Field Change Requests

**NW Natural Pre-Remedial Design Data Gaps Sampling
US Moorings Project Area – Fall 2020
Field Change Request Form**

Project Name: US Moorings Project Area **Subconsultant:** Anchor QEA, LLC

Field Change Request (FCR) Title: Subsurface Sediment Sampling Intervals for Alkylated PAH and TPH Analyses

Figure 1
Revised Proposed Angled Top of Riverbank Boring Locations

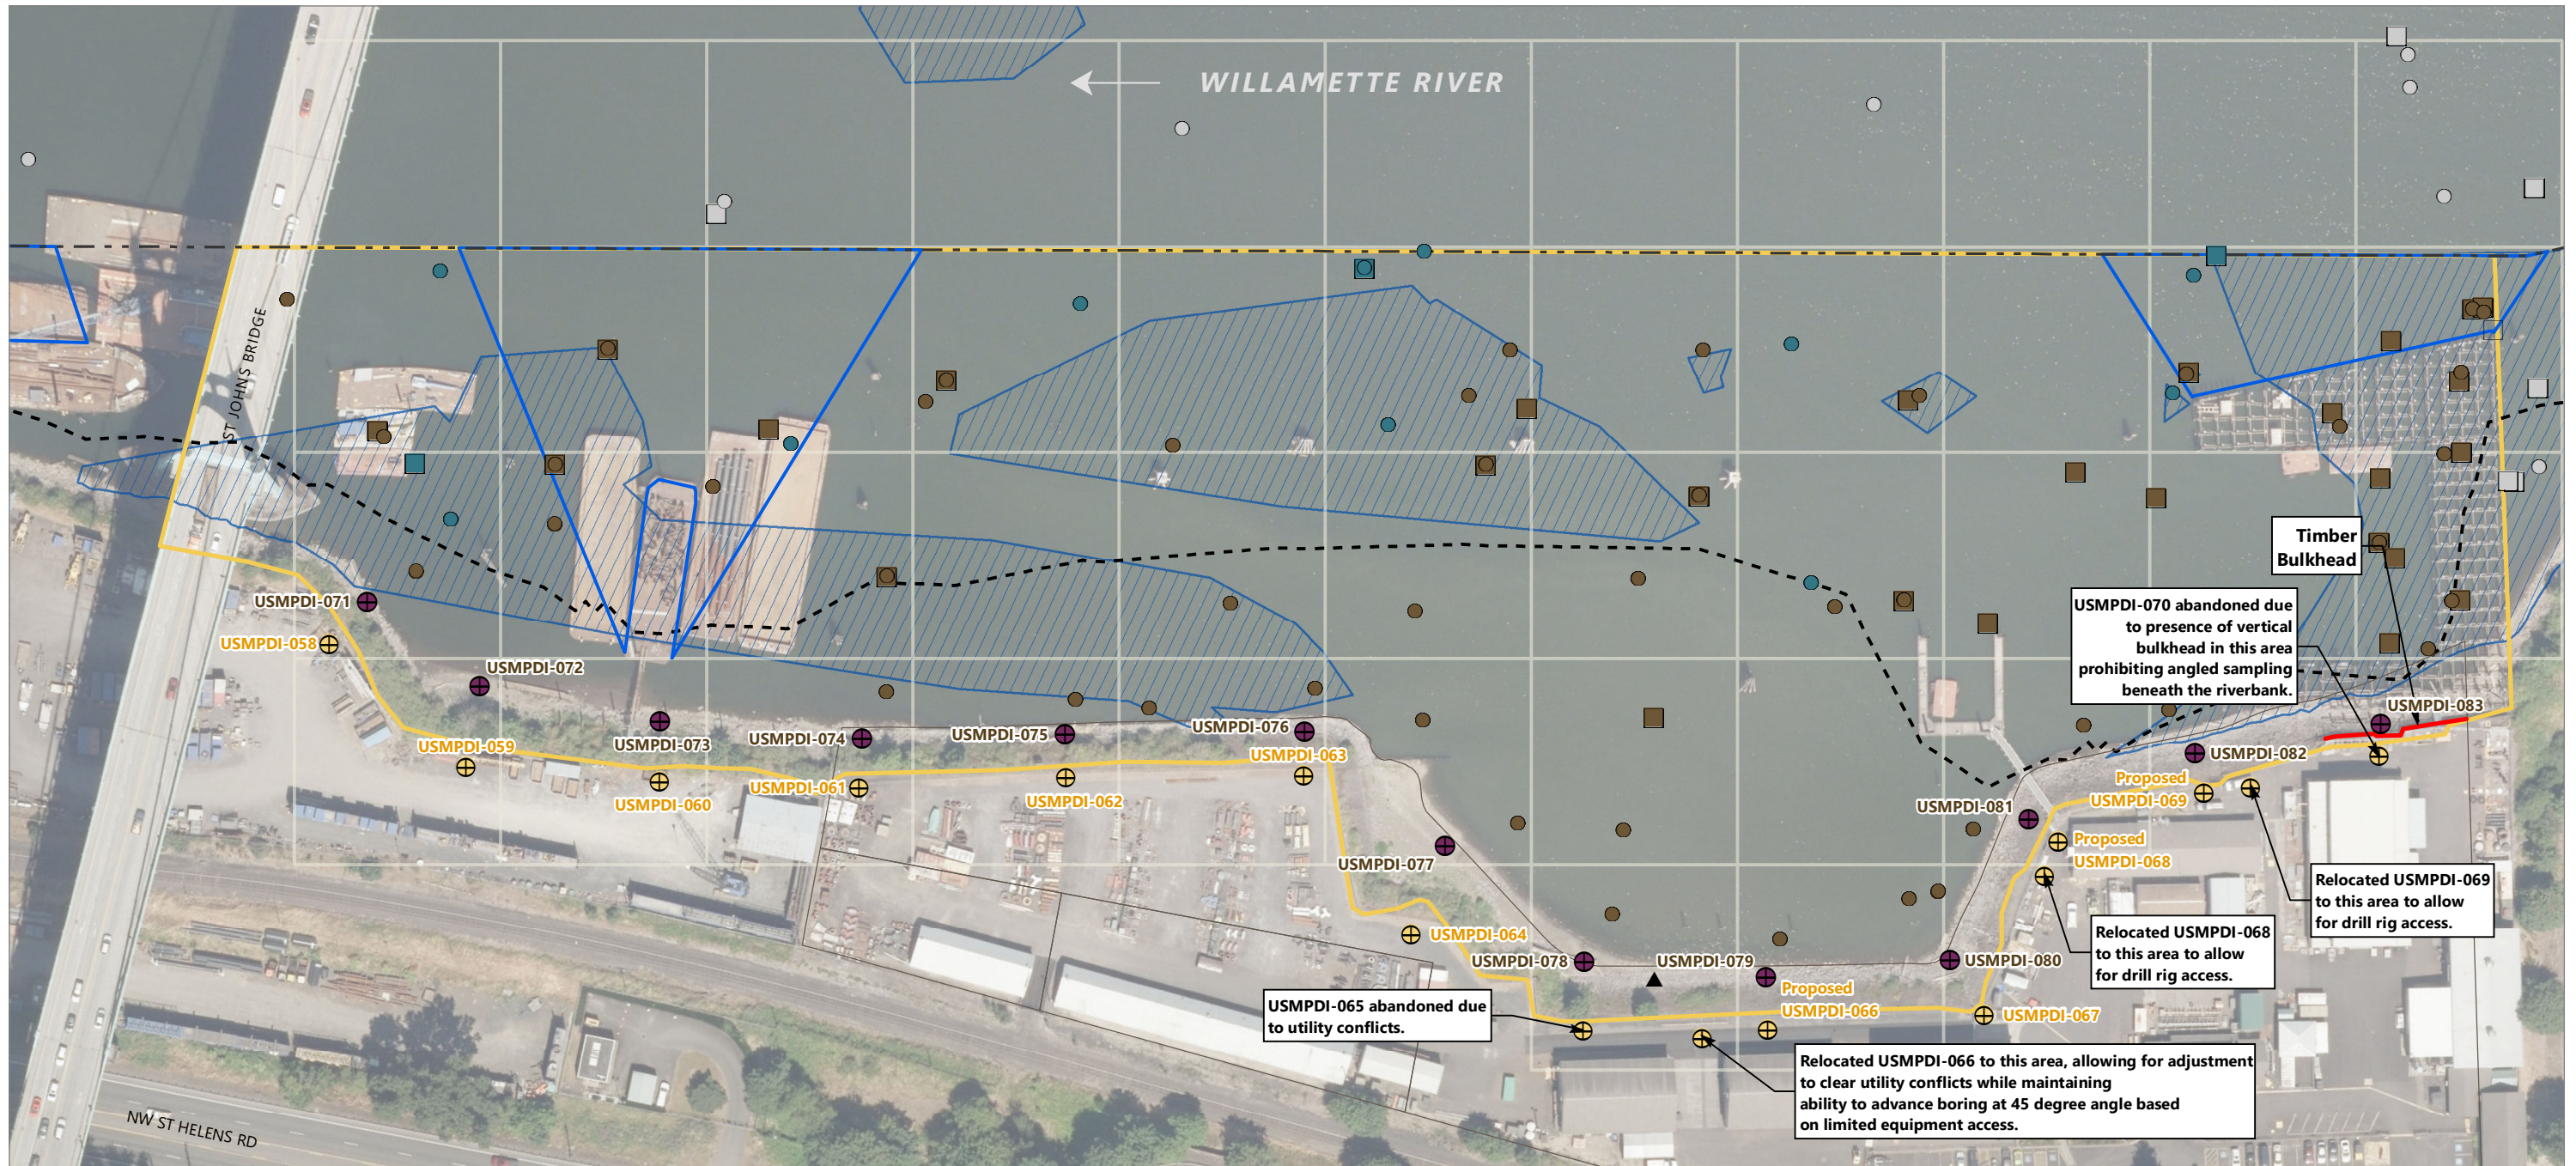
Recommended Change
<p>NW Natural proposes to abandon riverbank angled boring locations USMPDI-065 and USMPDI-070 due to the presence of utilities and timber bulkhead wall, respectively, and repositioning the locations to avoid these conflicts will result in a boring separation much closer than the proposed 150 feet and therefore unnecessary to support design. Consistent with Section 3.3.2 and Figure B3-2 of the <i>Revised Final Field Sampling Plan</i> (Appendix B to the PDIWP), NW Natural will attempt to collect three-point composite surface (0 to 1 foot below ground surface) soil samples from the face of the riverbank at locations USMPDI-078 and USMPDI-083 adjacent to the proposed abandoned riverbank angled boring locations USMPDI-065 and USMPDI-070, respectively, to characterize the riverbank soil quality in these areas. If collecting the surface samples is not feasible, NW Natural will discuss with EPA whether additional data is necessary to support remedial design.</p>

Figure 1
Revised Proposed Riverbank Surface Soil Sampling Locations

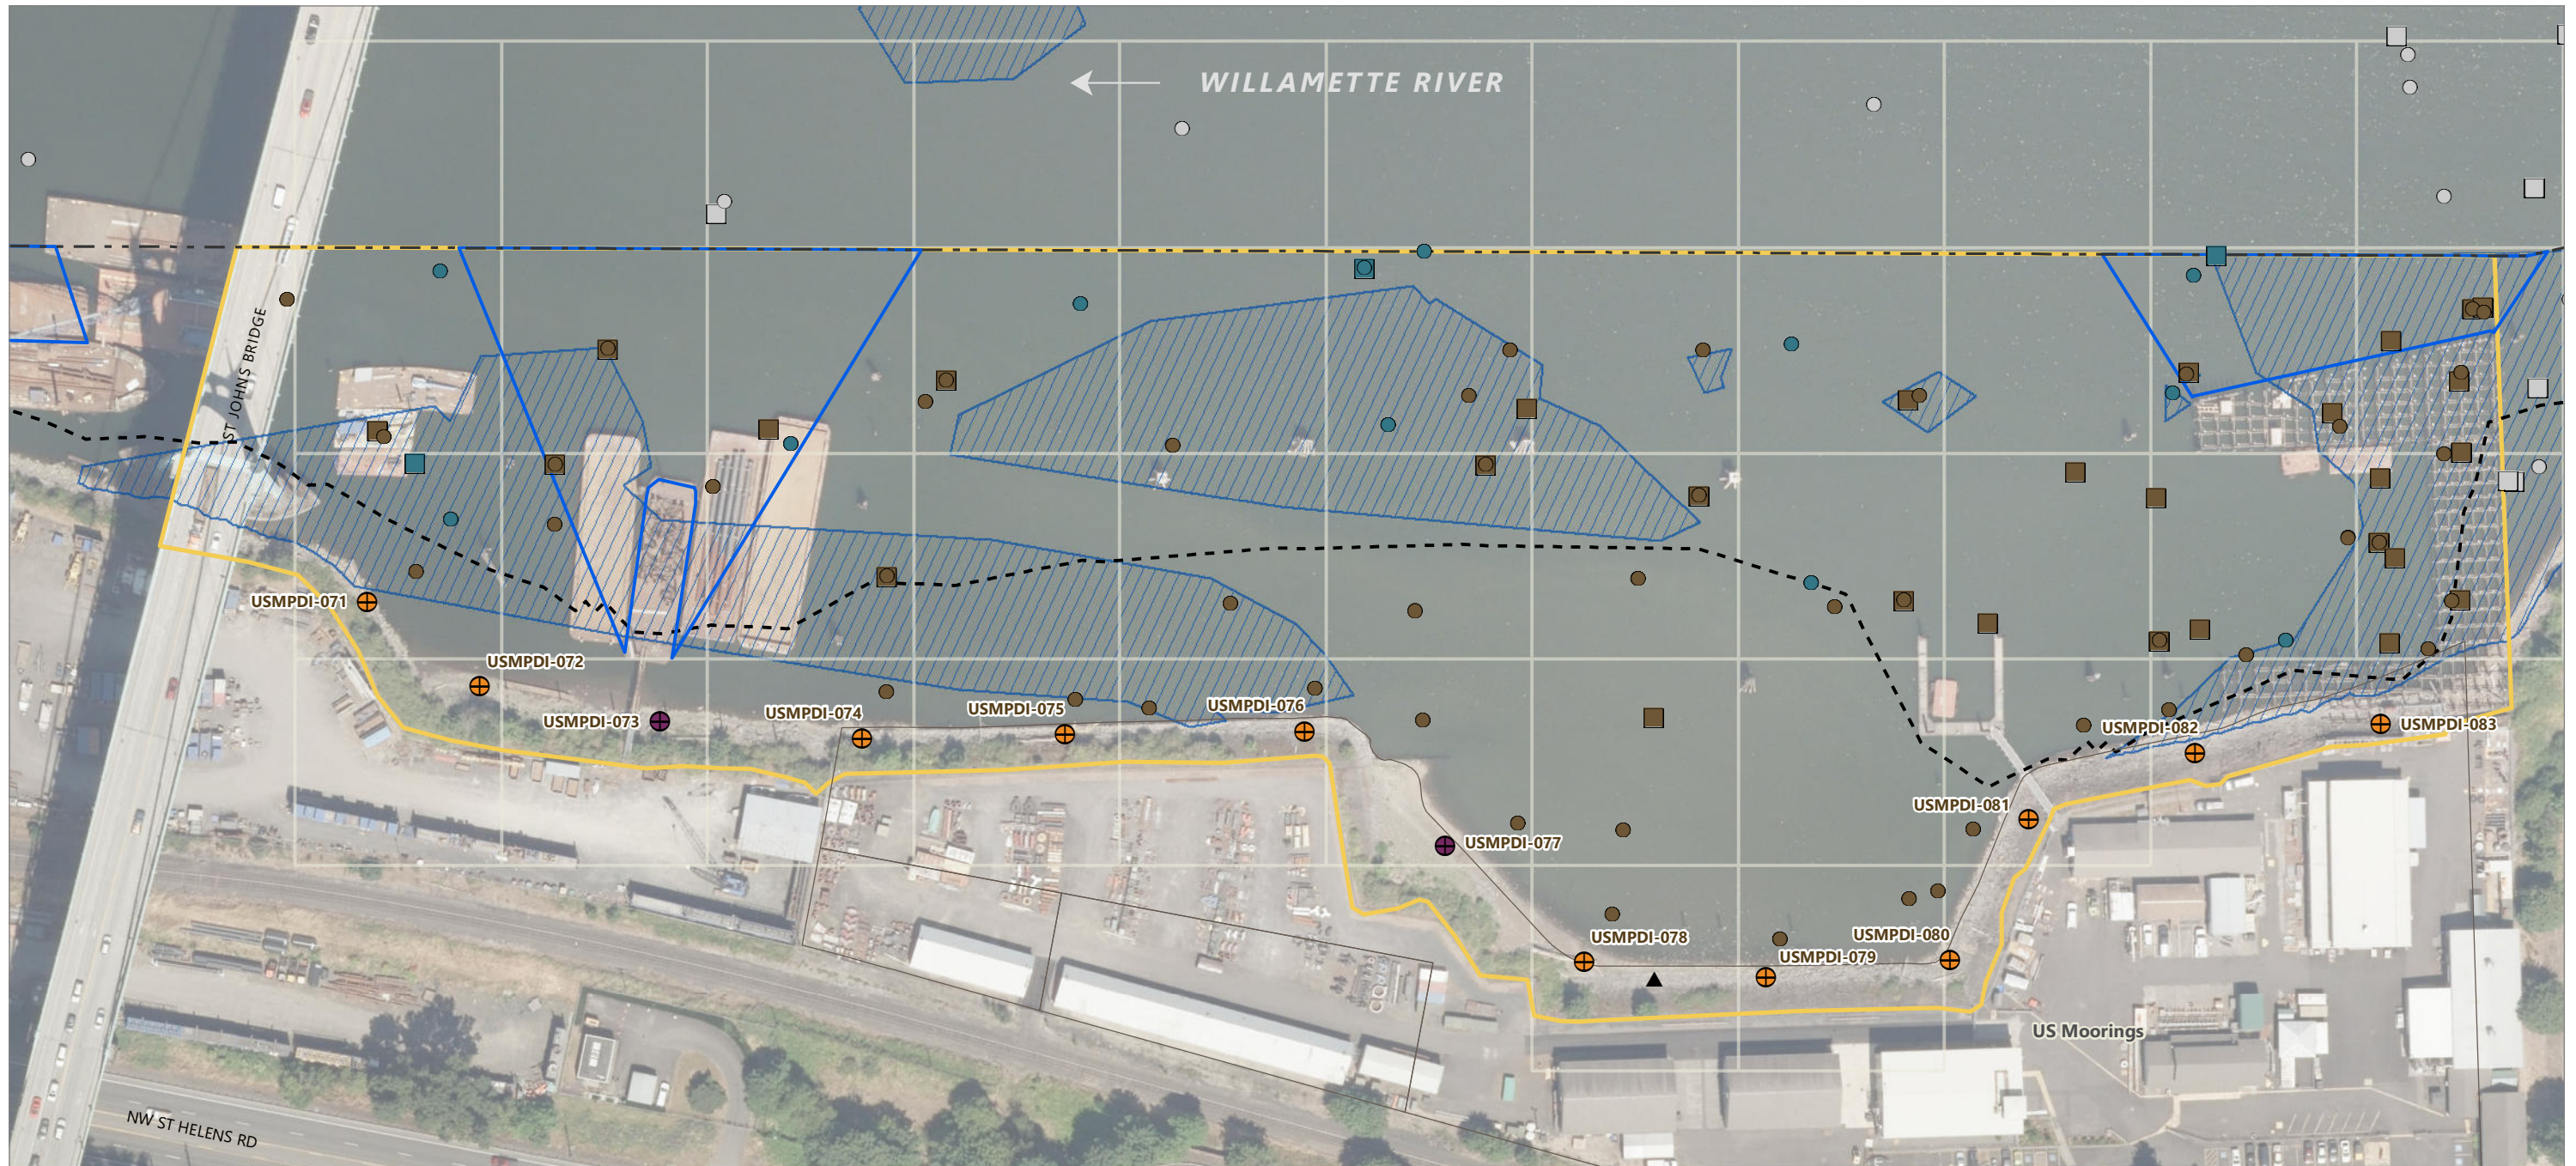
Recommended Change
<p>As verbally agreed with EPA oversight personnel during the visual reconnaissance, NW Natural proposes to abandon all riverbank surface soil locations other than USMPDI-073 and USMPDI-077 due to the lack of surface erodible soils, as photograph documented in Attachment A. In addition, due to the small area of potentially erodible solids at locations USMPDI-073 and USMPDI-077, a two-point composite grab sample was homogenized to create the sample at these locations, and the mid-point of the two samples will be used as the sampling location.</p>

USMPDI-071

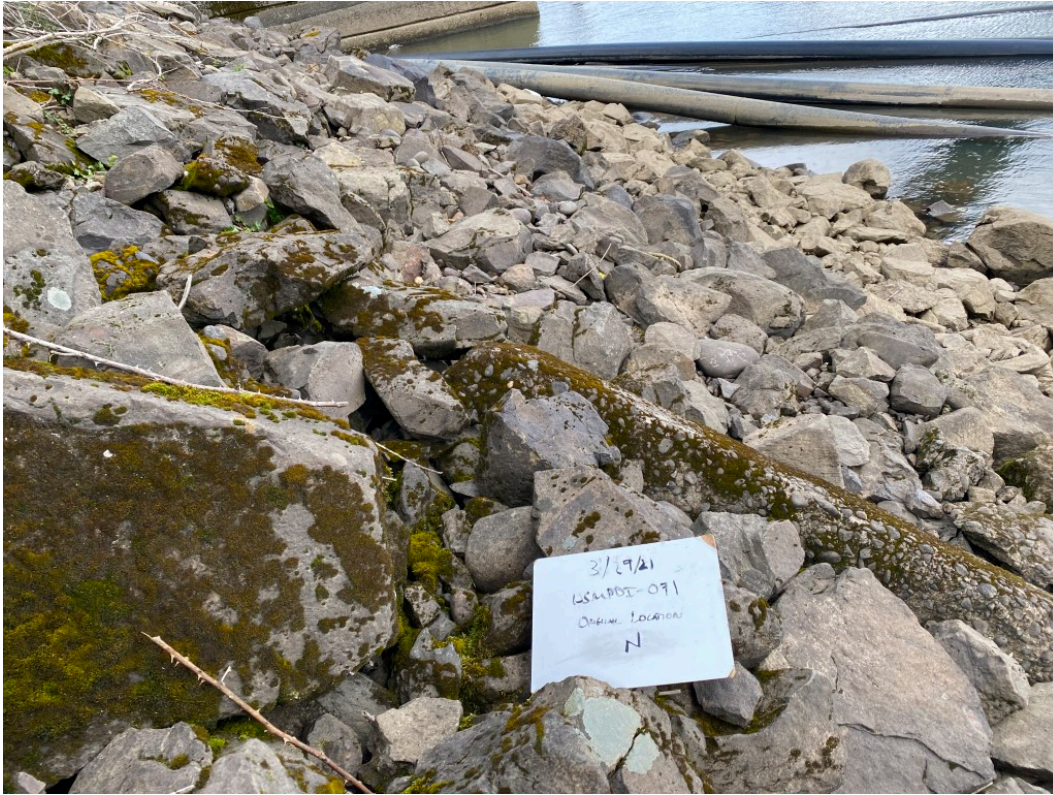
Facing North, No Erodible Soils Present

USMPDI-072

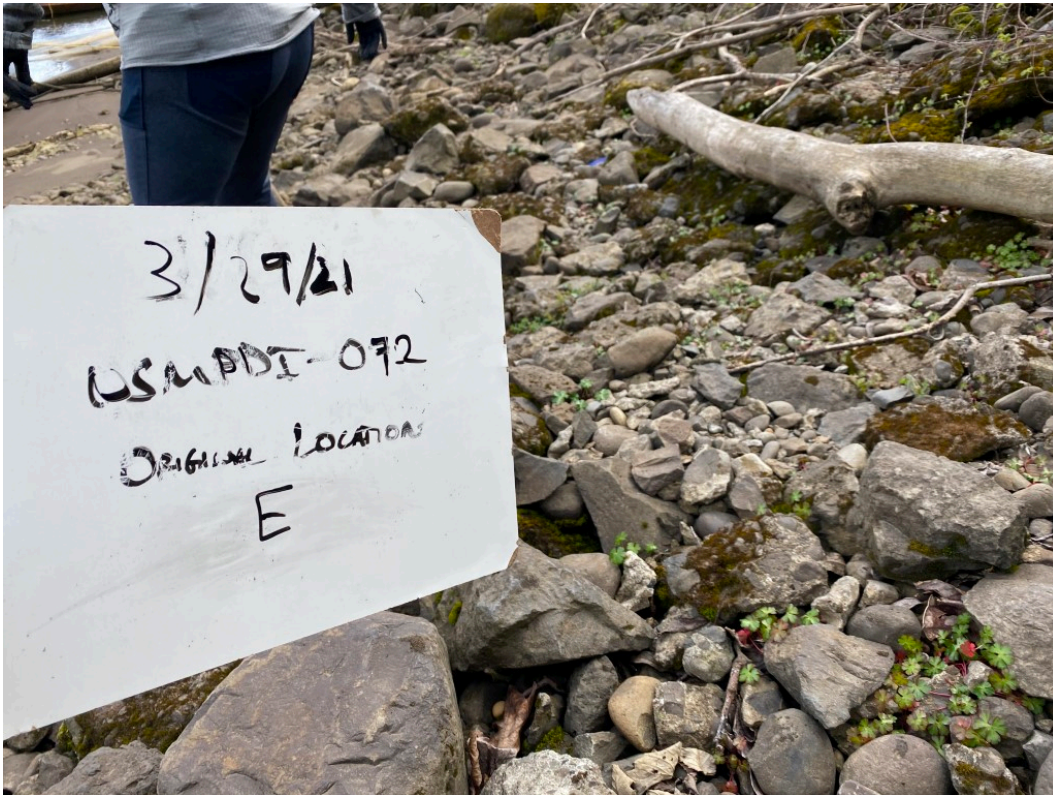
Facing East, No Erodible Soils Present

USMPDI-074

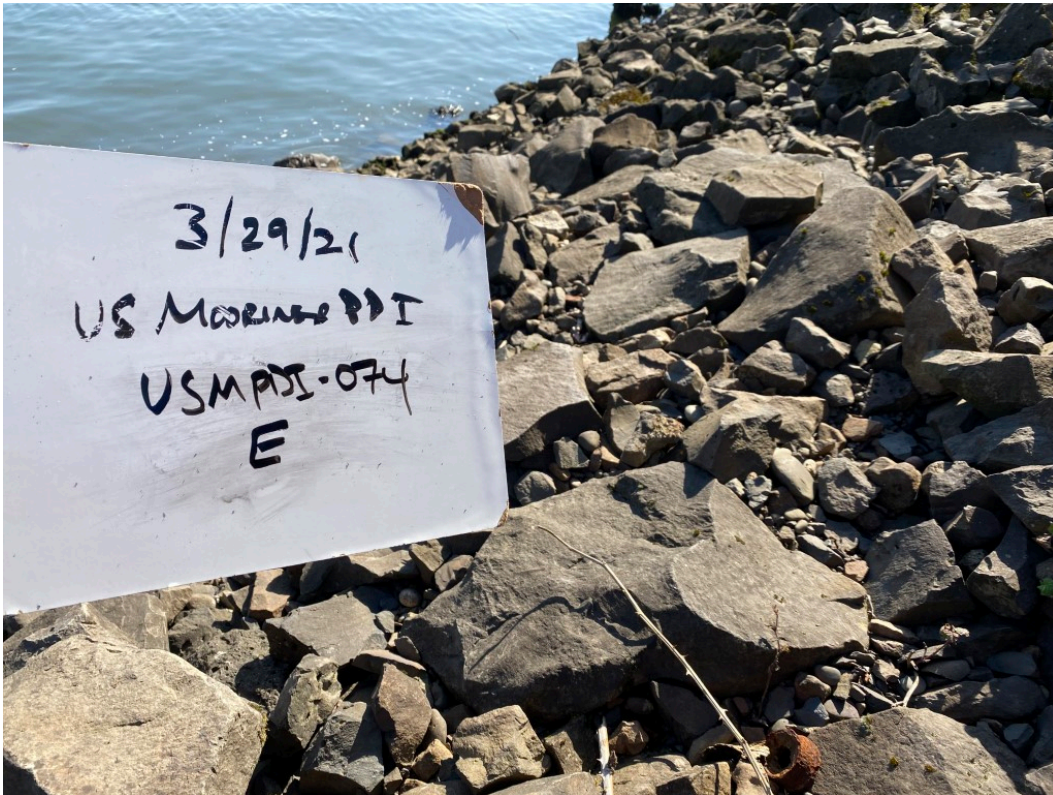
Facing East, No Erodible Soils Present

USMPDI-075

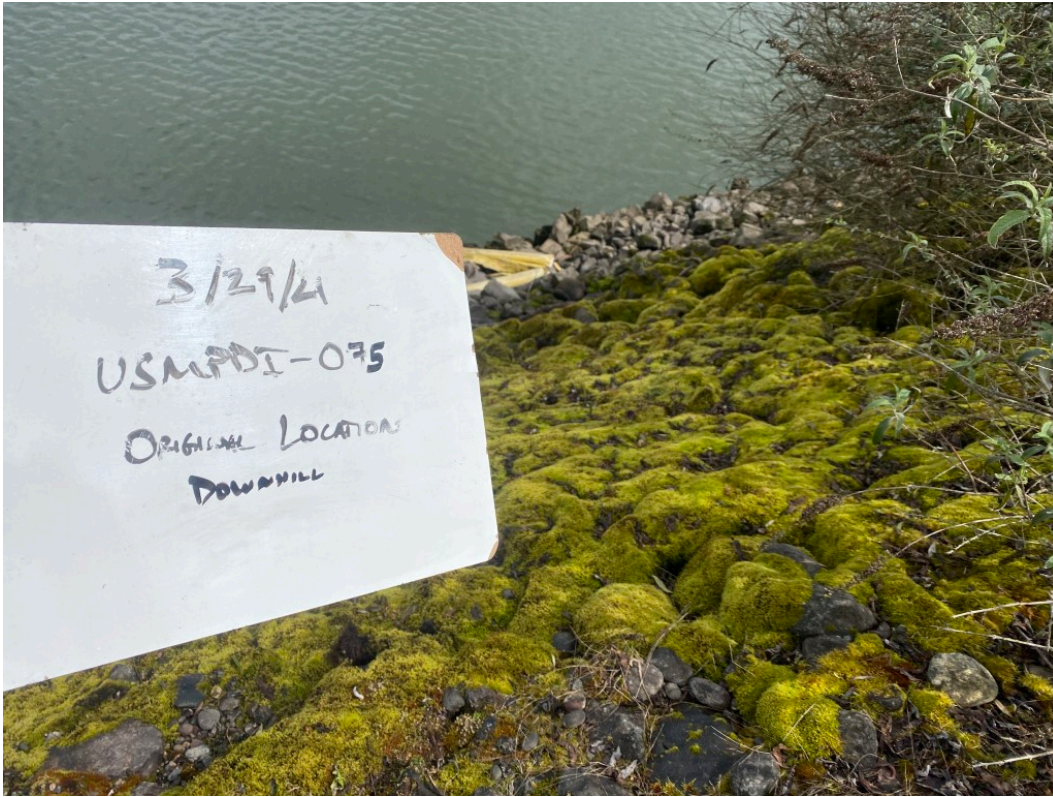
Facing North, No Erodible Soils Present

USMPDI-076

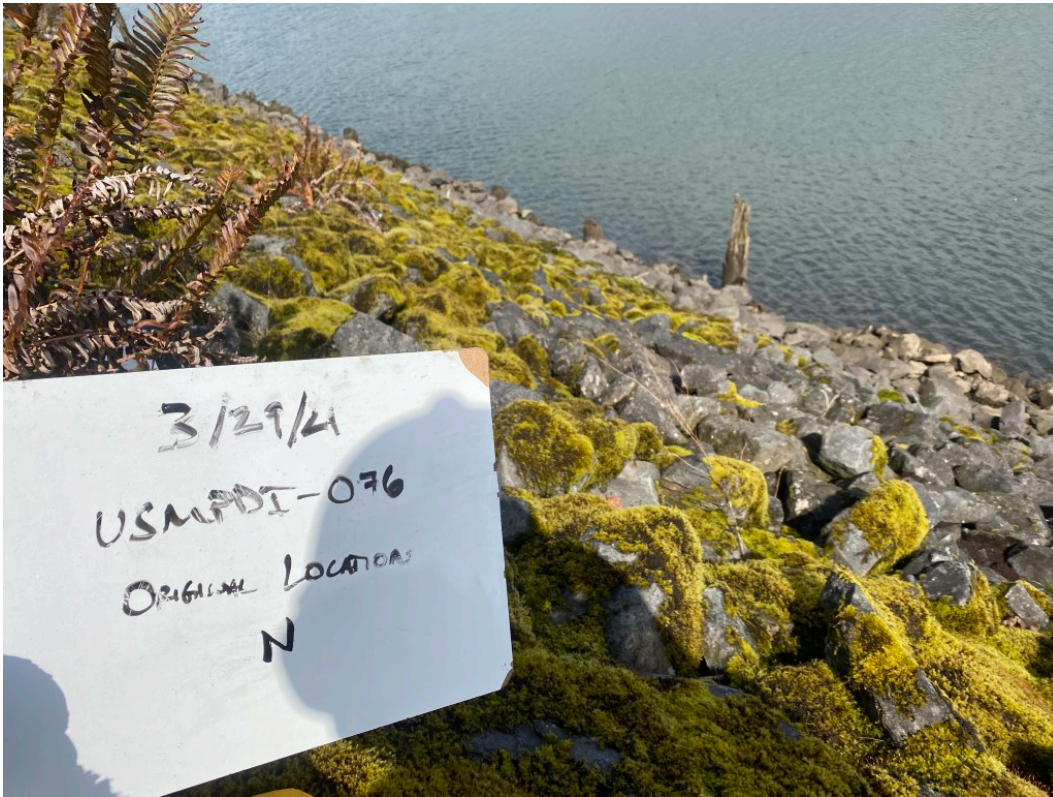
Facing North, No Erodible Soils Present

USMPDI-077

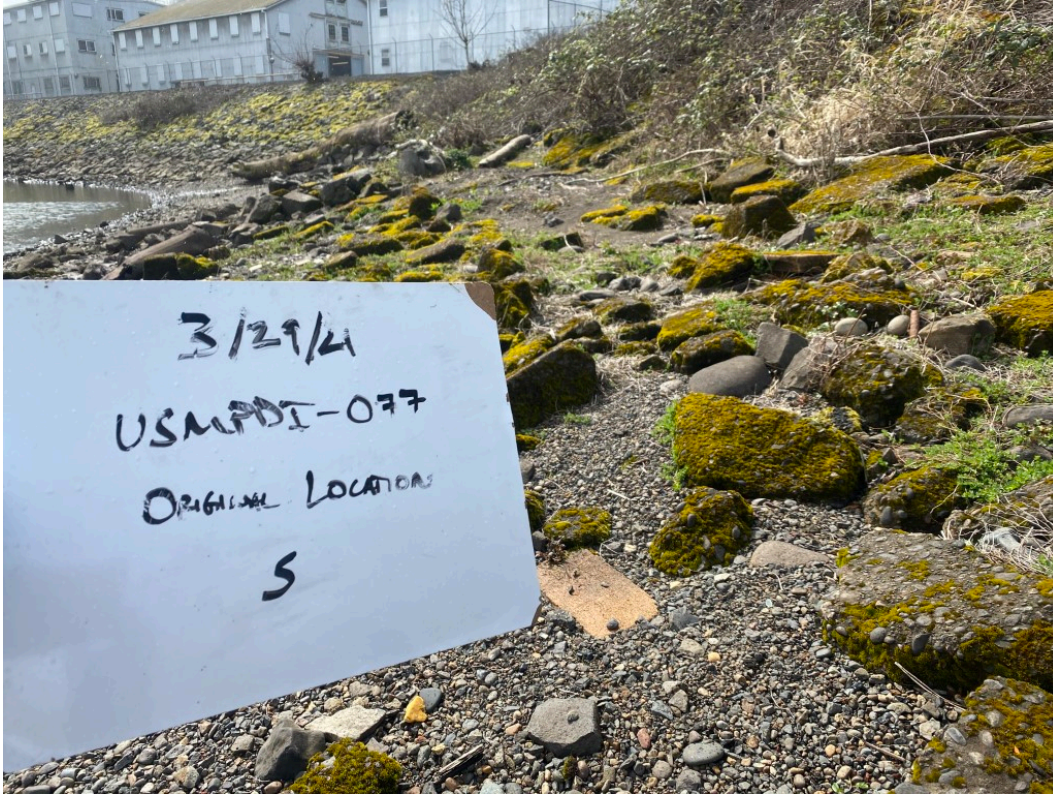
Facing South, Erodeable Soils Present
